Title - Sujet Greenhouse Climate Control System Système de régulation d'ambiance pour serres				
Solicitation No N° de l'invitation		Date		
01686-210518/B		2021-07-28		
Client Reference No N° de ré 01686-21-0518	éférence du client			
GETS Reference No N° de ré PW-\$KIN-710-8440	férence de SEAG			
File No N° de dossier	CCC No./N° CCC - FMS	No./N	N° VME	
KIN-0-54210 (710)				
Solicitation Closes	L'invitation pre	nd f	in	
at - à 02:00 PM	Eastern Daylight Sav	ing T	ime EDT	
on - le 2021-08-27	Heure Avancée de l'I	Est HA	AE	
F.O.B F.A.B.				
Plant-Usine: Destination	: 🗸 Other-Autre:]		
Address Enquiries to: - Adress	ser toutes questions à:		Buyer Id - Id de l'acheteur	
Dunphy, Ken			kin710	
Telephone No N° de télépho	ne	FAX	No N° de FAX

Greenhouse Climate Control System - Harrow RDC

SUPPLEMENTAL INFORMATION

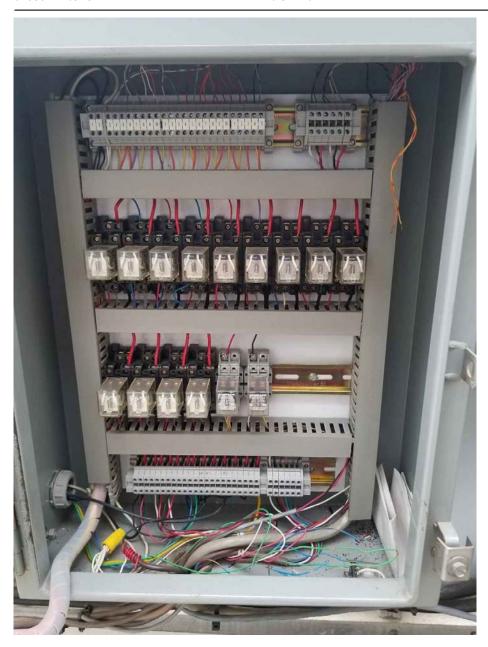
- Q1. The pictures show just the equipment in a zone vent motor, shade motor etc., is there a contactor panel that contains all the forward and reversing contactors for vents, shade, rollups, HAF fans and HID lights that and is it separate from the computer?

- A1. See attached picture of contactor panel. The contactors are controlled via 24VAC by the Omron relays shown in picture 2.
- Q2. Are we to supply all power control contactors for the specified zone equipment?

On/Off/Auto controls for relays. All needs to be replaced.

Relay Box. All needs to be replaced
